CONTRACT CHANGE ORDER NO. _____
SHEET ___ OF ___

MARK	DATE	DESCRIPTIONS	BY	CH'D	CCO#
1	08/02/11	FLOORBEAM DIAPHRAGM	GB	MN	143

SAN FRANCISCO OAKLAND BAY BRIDGE
EAST SPAN SEISMIC SAFETY PROJECT
SELF-ANCHORED SUSPENSION BRIDGE
(SUPERSTRUCTURE & TOWER)

TYPICAL FLOORBEAM DETAILS NO. 9

ALTERNATE DIAPHRAGM TO FLOORBEAM WELD DETAIL
AT FLOORBEAMS AND INTERMEDIATE FLOORBEAMS
AT EAST TRANSITION

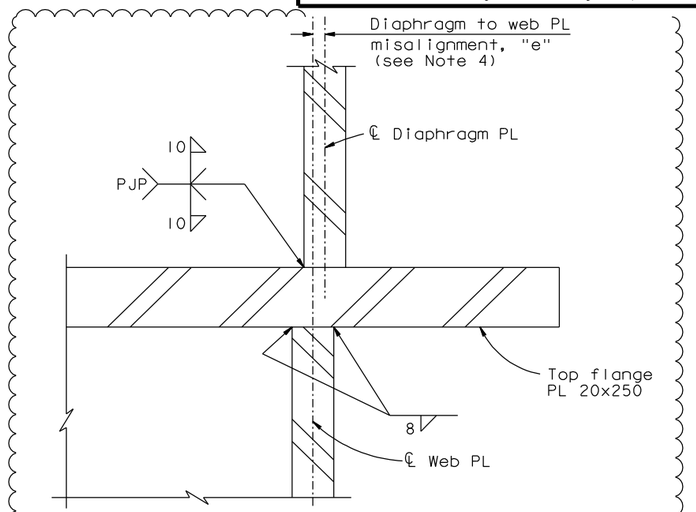
1. For Sections C-C and D-D, see "Typical Floorbeam Details No. 3" sheet.
2. Section A-A is typical at all floorbeams that do not have Chevrons, including floorbeams in east transition. For these locations, see "Floorbeam At East Transition" sheets and Detail C.
3. For termination of diaphragm edge plate and fin edge plate, see "Typical Girder Details No. 16" sheet.
4. The alternate weld detail for diaphragm to floorbeam web connection shown in Detail C is acceptable on a fit-for-purpose basis to allow an increase in diaphragm to web plate misalignment, "e", of up to 10 mm at floorbeams and intermediate floorbeams in east transition spans.
